## HAZOP / SIL REPORT

**BUPC MEG Plant HAZOP & SIL Report –  
N2 and Air Compressor  
Detailed Design**

**Client Report No: BUPC-17811-OO-0703**

DRAWING TITLE: 17811-03 P&ID FOR NITROGEN GAS BOOSTER

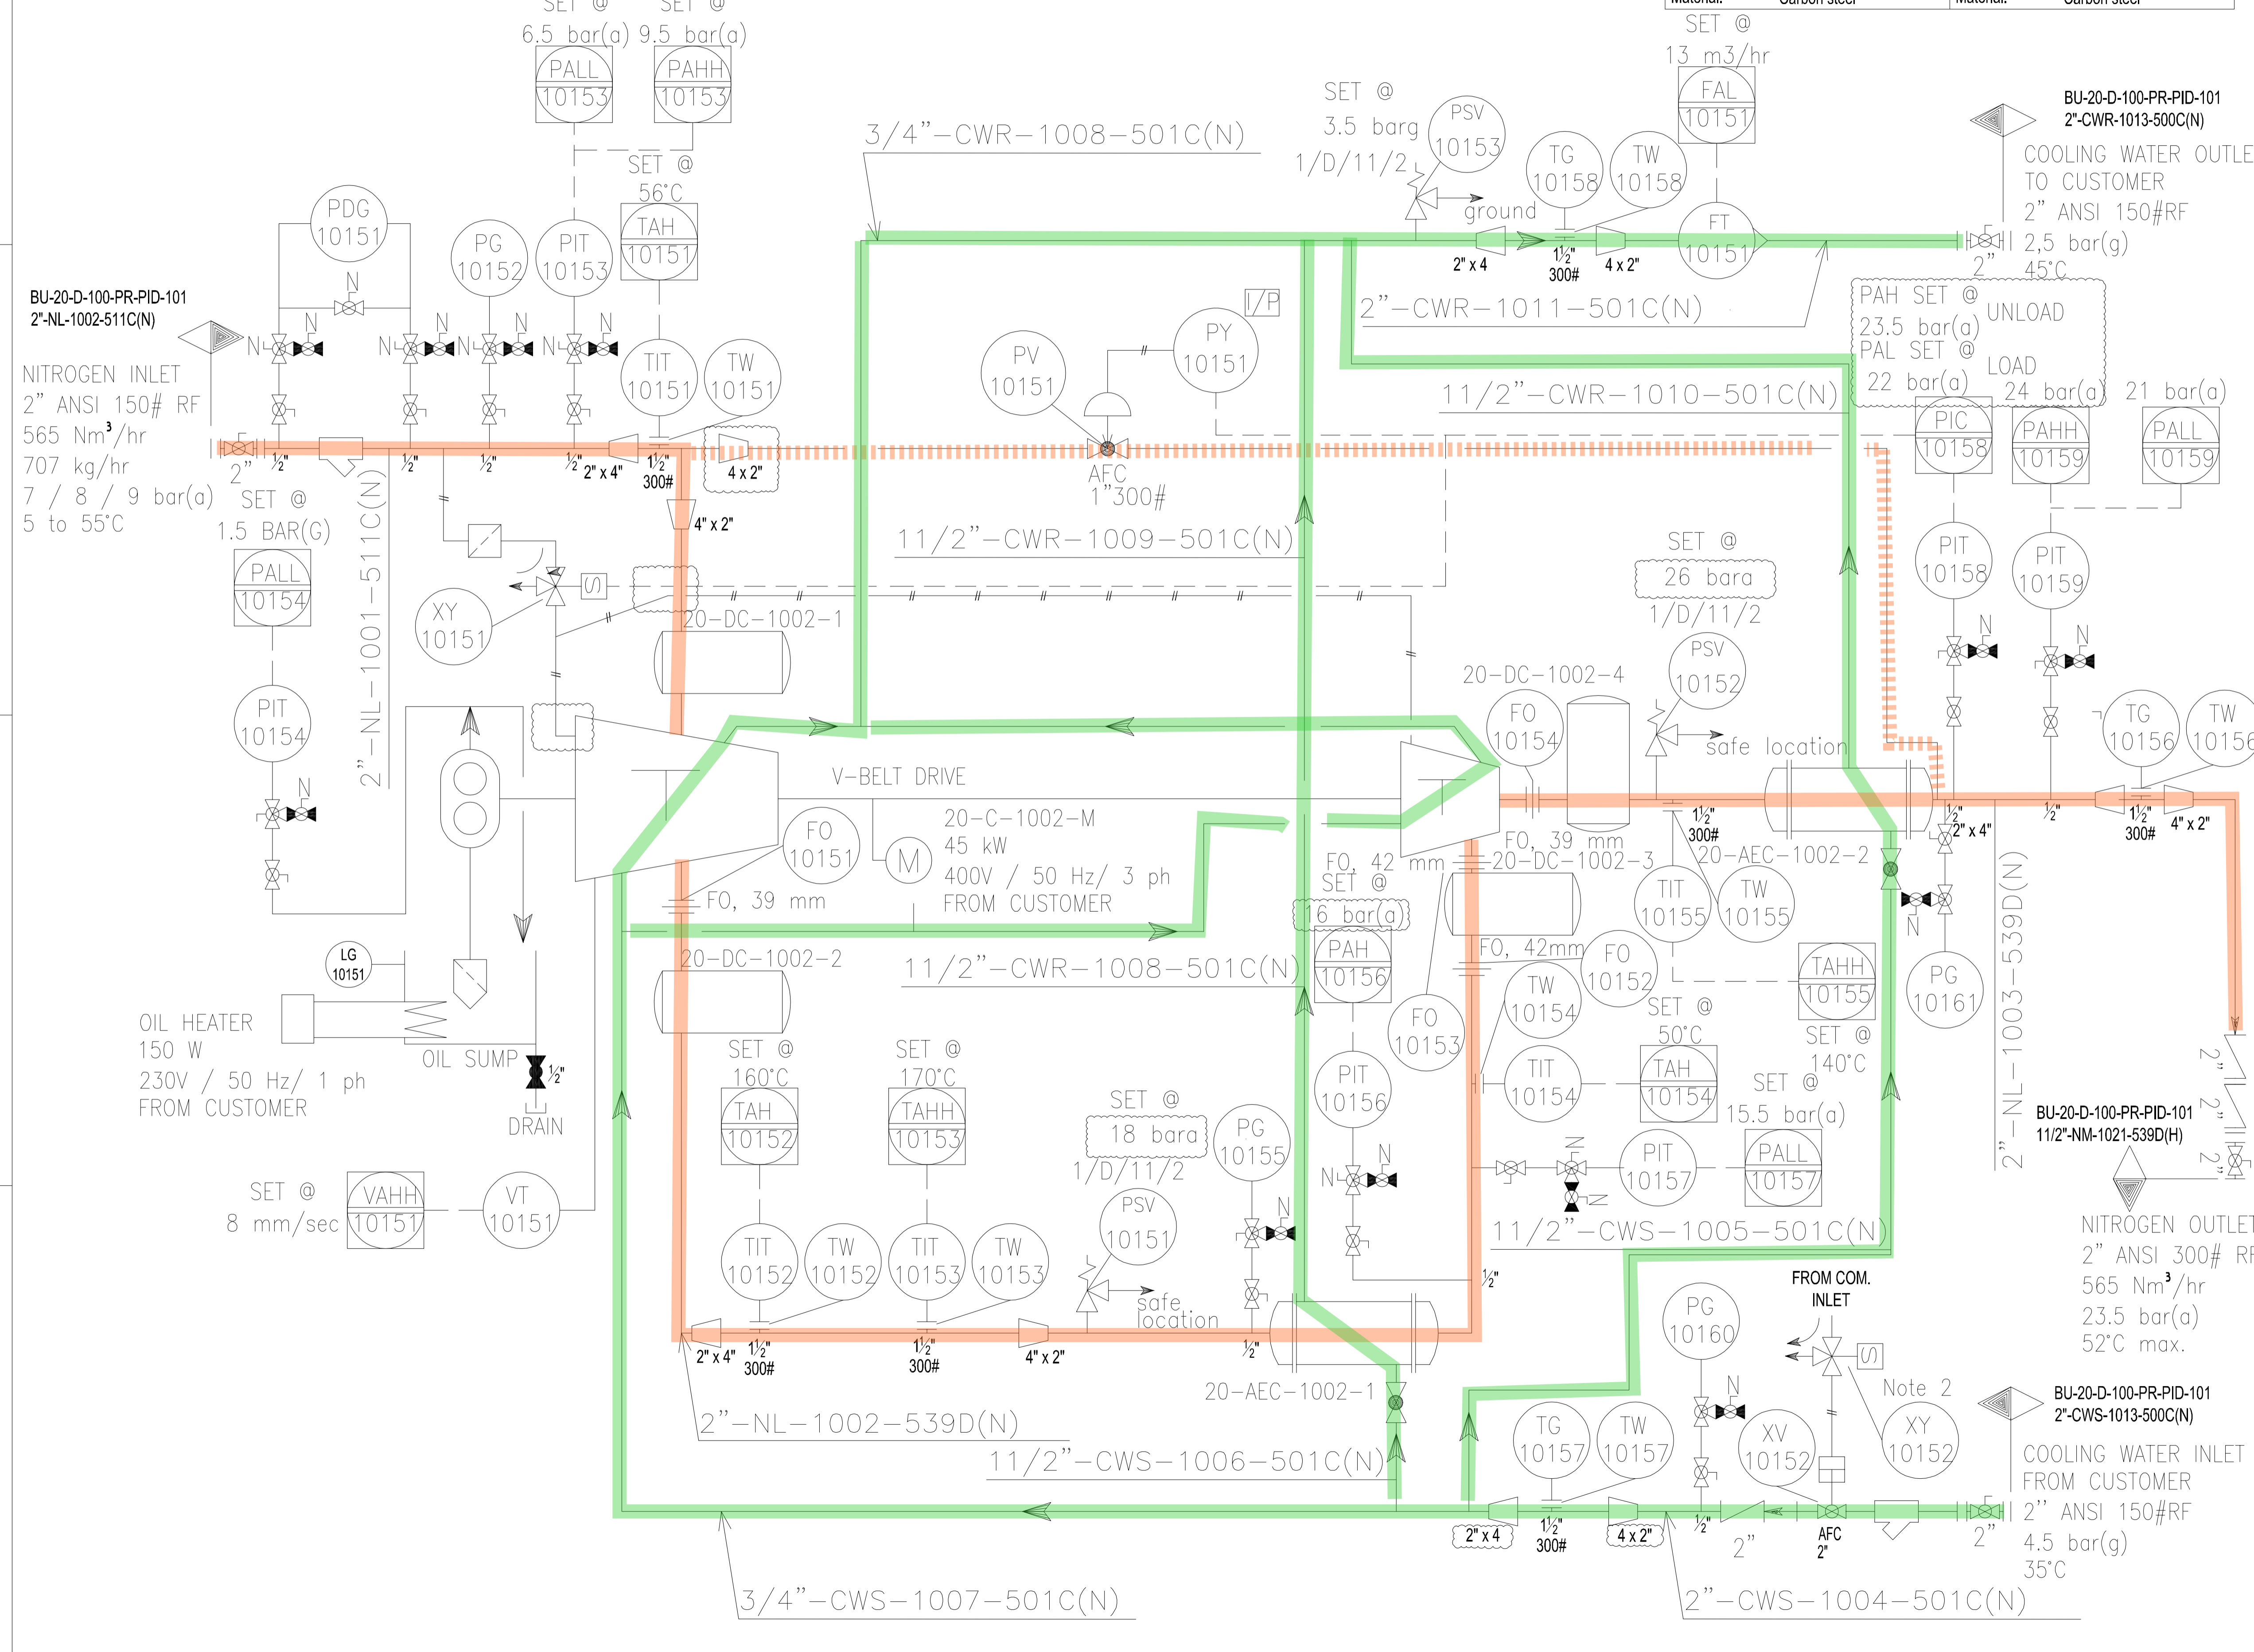
01.1.1.1	Flow	No / Not	No/Less Flow	No nitrogen supply from Plant	1. No Supply to the compressor leading to underpressure at the suction side of the compressor. Worst case is if recycle line is closed. No vacuum is expected, however the 1stage discharge pressure will decrease. Increase of temperature of the second stage exceeding the design temperature of the Compressor. Less supply to the end users. Vibrations of the axis of the compressor is possible. No loss of containment. No hazardous consequence. Asset damage (L) only 2nd stage < 5000 US\$.	L	1. PIT-10153-PALL to Trip 20-C-1002 (UCP ESD) 2. PIT-10159-PALL to Trip 20-C-1002 (UCP ESD) 3. TIT-10155-TAHH to trip 20-C-1002 (UCP ESD)	1	3	SIL 0	1. PIT-10153-PALL to Trip 20-C-1002 (UCP ESD) 2. PIT-10159-PALL to Trip 20-C-1002 (UCP ESD) 3. TIT-10155-TAHH to trip 20-C-1002 (UCP ESD)	3	No action

01.1.2.1	Flow	No / Not	No/Less Flow	Blocked Filter/Strainer in supply line (inlet)	1. No Supply to the compressor leading to underpressure at the suction side of the compressor. Worst case is if recycle line is closed. No vacuum is expected, however the 1stage discharge pressure will decrease. Increase of temperature of the second stage exceeding the design temperature of the Compressor. Less supply to the end users. Vibrations of the axis of the compressor is possible. No loss of content. No hazardous consequence. Asset damage (L) only 2nd stage < 5000 US\$.		1. PIT-10153-PALL to Trip 20-C-1002 (UCP ESD) 2. PIT-10159-PALL to Trip 20-C-1002 (UCP ESD) 3. TIT-10155-TAHH to trip 20-C-1002 (UCP ESD)	1	3	SIL 0	1. PIT-10153-PALL to Trip 20-C-1002 (UCP ESD) 2. PIT-10159-PALL to Trip 20-C-1002 (UCP ESD) 3. TIT-10155-TAHH to trip 20-C-1002 (UCP ESD)	3	No action

01.1.3.1	Flow	No / Not	No/Less Flow	Motor or V-belt Drive Failure Compressor 20-C-1002-M	1. No Supply to the end user . Discharge pressure of the Compressor will decrease. No supply to the end users. No hazardous consequence. No asset consequences		1. PIT-10159-PALL to Trip 20-C-1002 (UCP ESD) 2. PIT-10154-PALL to Trip 20-C-1002 (UCP ESD) (lube oil pressure low will stop the compressor)

01.2.1.1	Flow	More	More/High Flow	More flow over the recycle line by 'Fail Opened AFC PV-10151 or control failure to opened valve in case AFC should be NOT fully opened.	1. Decreased pressure and temperature in the second stage of the compressor. Less supply to the plant/ end user. No hazardous consequence; No asset consequence.		1. PIT-10159-PALL to trip 20-C-1002 (UCP ESD)

02.1.1.4	Flow	No / Not	No/Less Flow	No Cooling Water supply from Plant	Overheating of cooling water in aftercooler 20-AEC-1002-2. Exceeding of the design temperature of the tubes inside the aftercooler (95 deg C). Maximum temperatures of the cooling water (140 deg C -equal to uncooled nitrogen- can be reached. Boiling of water may start at ca. 120 deg C. Tube rupture is possible. Nitrogen induced into the cooling water and exceeding also the design pressure of the cooling water system. Loss of containment is possible. Maximum release with full rupture- 0.2 kg/s (707 kg/h /). Full rupture is not expected. No suffocation of people is expected (open area, 4 sides open). Remote suffocation risk to people is possible (safety distance is ca. 1-2 meters. Severity S=S2 (S2 is equal to C A according risk matrix) Asset damage (L) is ca. 10 k. US\$ L=S1; Most severe risk is people risk (S=S2).	S	1. TIT-10155-TAHH to Trip 20-C-1002 (UCP ESD) 2. FT-10151-FAL to Trip 20-C-1002 by operator (only 1 alarm is counting for a risk reduction) 3. PSV-10153 @3.5 barg to ground	2	3	SIL 1	1. TIT-10155-TAHH to Trip 20-C-1002 (UCP ESD) <i>SIL 1 SIF in SIS</i> 2. FT-10151-FAL to Trip 20-C-1002 by operator (only 1 alarm is counting for a risk reduction) 3. PSV-10153 @3.5 barg to ground (RRF=100)	4	No action

02.1.1.5	Flow	No / Not	No/Less Flow	No Cooling Water supply from Plant	No Cooling of Compressor 20-C-1002. Not exceeding of the design temperature (170 deg C for valves, 210 deg C for casing and internal cooling water circuit); temperature in the discharge of the 1st stage or 2nd stage of the compressor may go up ca. 170 deg C. No loss of containment. No hazardous consequence. No Asset damage (L) is expected.		1. TIT-10155-TAH to Trip 20-C-1002 (UCP ESD) 2. FT-10151-FAL to Trip 20-C-1002 (UCP ESD)

DRAWING TITLE: 17811-03 P&ID FOR INSTRUMENT AIR COMPRESSOR

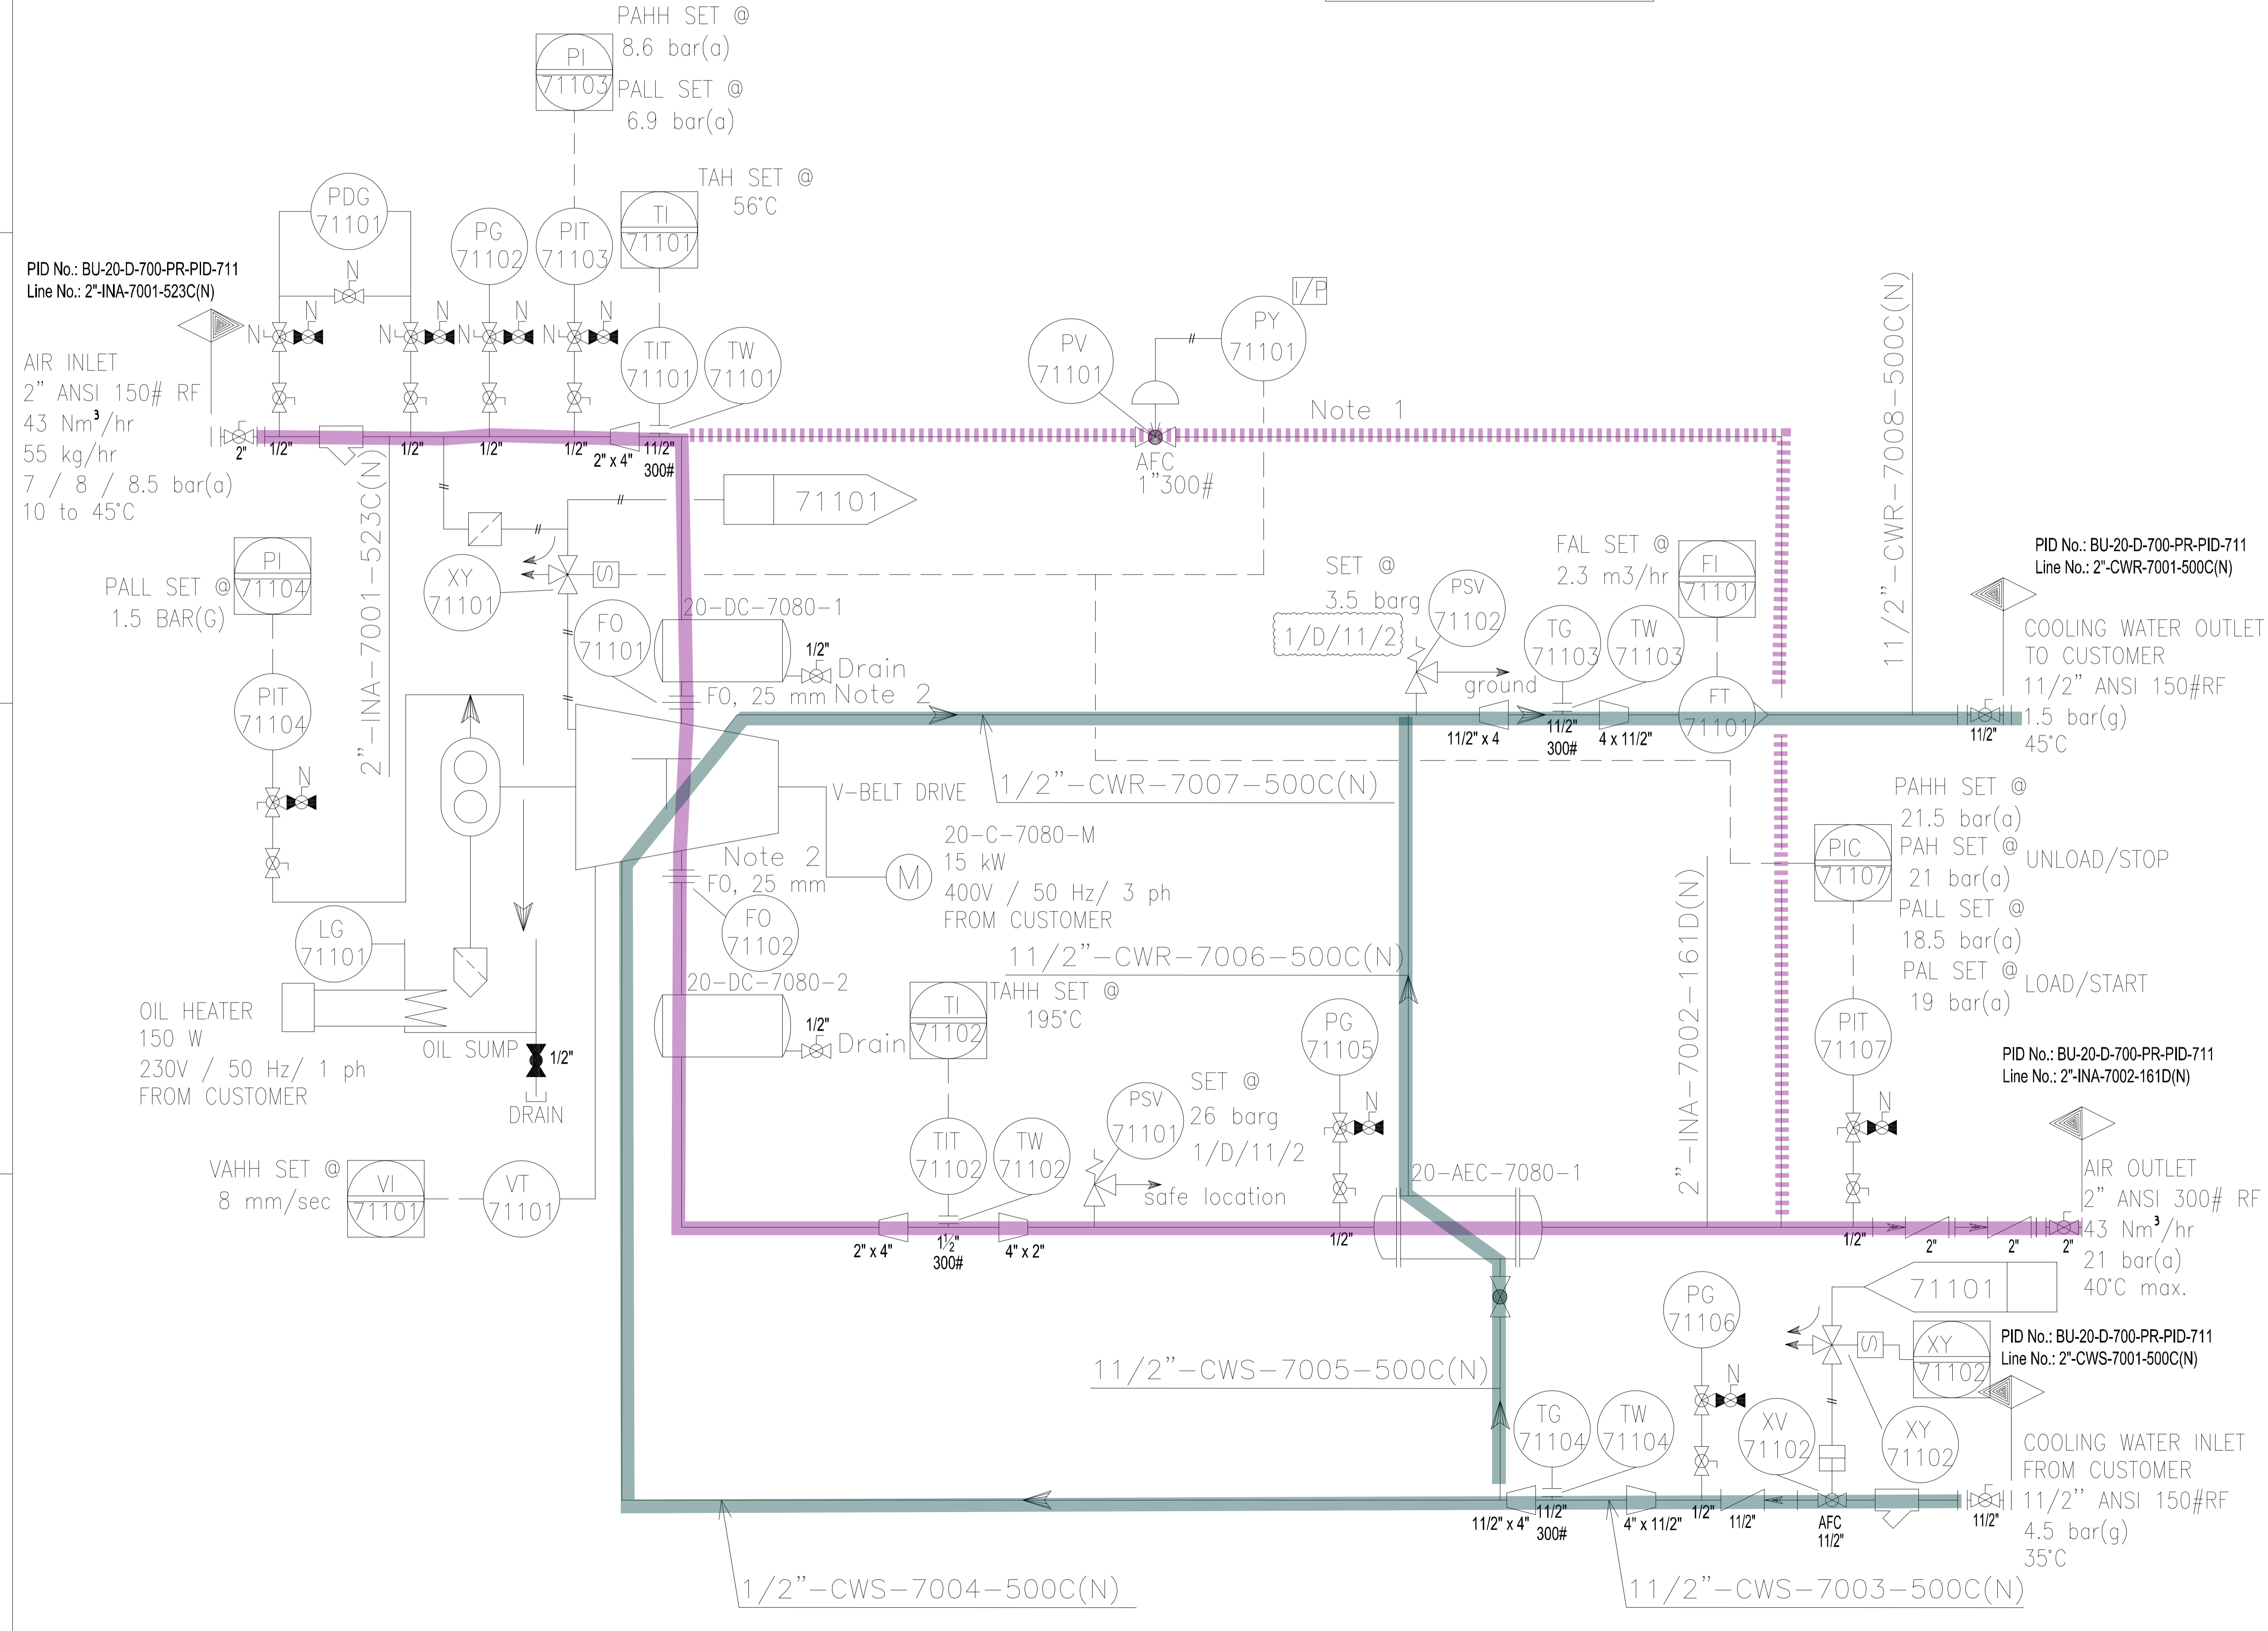
03.1.1.1	Flow	No / Not	No/Less Flow	No Air supply from Plant	1. No Supply to the compressor leading to underpressure at the suction side of the compressor. Worst case is if recycle line is closed. No vacuum is expected, however the discharge pressure will decrease. Increase of temperature of the first stage exceeding the design temperature of the Compressor. Less supply to the end users. Vibrations of the axis of the compressor is possible. No loss of containment. No hazardous consequence. Asset damage (L) < 5000 US\$.	L	1. PIT-71103-PALL to Trip 20-C-7080 (UCP ESD) 1. PIT-71107-PALL to Trip 20-C-7080 (UCP ESD) 3. TIT-71102-TAHH to trip 20-C-7080 (UCP ESD)	1	3	SIL 0	1. PIT-71103-PALL to Trip 20-C-7080 (UCP ESD) 1. PIT-71107-PALL to Trip 20-C-7080 (UCP ESD) 3. TIT-71102-TAHH to trip 20-C-7080 (UCP ESD)	3	No action

03.2.1.1	Flow	More	More/High Flow	More flow over the recycle line by 'Fail Opened AFC PV-71101 or control failure to opened valve in case AFC should be NOT fully opened.	1. Decreased pressure and temperature in the second stage of the compressor. Less supply to the plant/ end user. No hazardous consequence; No asset consequence.		1. PIT-71107-PALL to trip 20-C-7080 (UCP ESD)
